HYUNDAI Technical Service Bulletin

NUMBER
26-BE-002H

SUBJECT: INOPERATIVE HORN ASSEMBLY REPLACEMENT

Description: Some Tucson Internal Engine Combustion (ICE), Hybrid, and Plug-in Hybrid (NX4, NX4 HEV, and NX4 PHEV) vehicles may have an inoperable horn that may be caused by foreign substances causing internal parts to oxidize. This bulletin provides instructions on how to replace both inoperable horns.

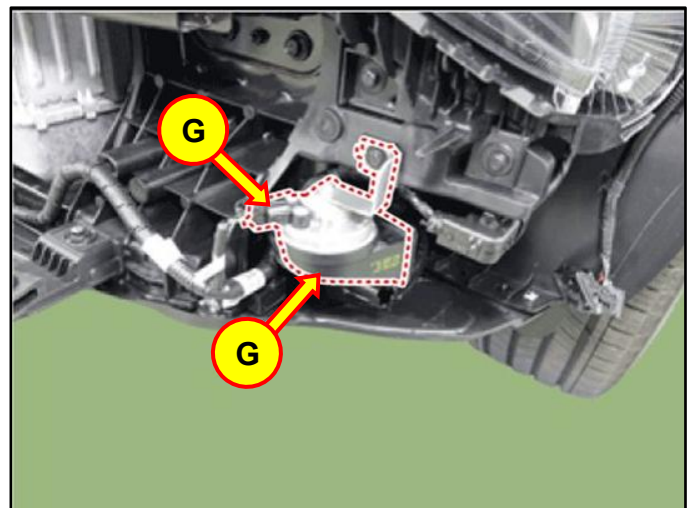
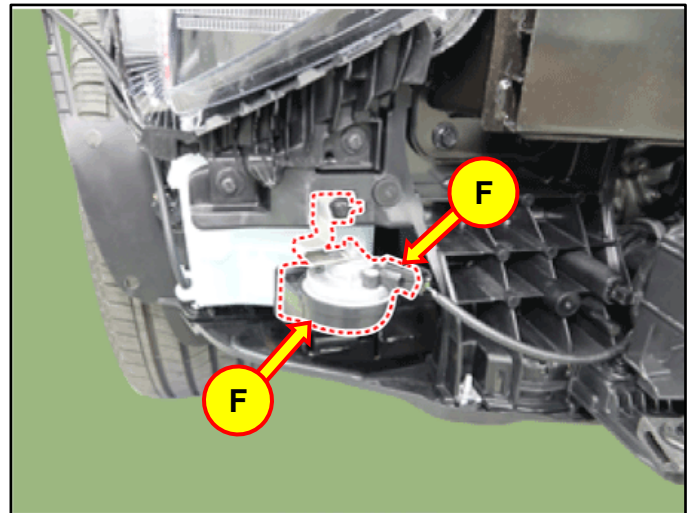
5. Refer to the shop manual to remove both horns (F, G) by disconnecting the horn connector and removing the mounting bolt:

lb-ft	7.25
lb-in	87
N.m	9.8

6. Install the new high and low-pitch horns in the reverse order of removal.
7. Reinstall bumper and connect 12V battery in the reverse order of the removal process.
8. Test the horns to confirm proper operation.
9. This service procedure is now complete.
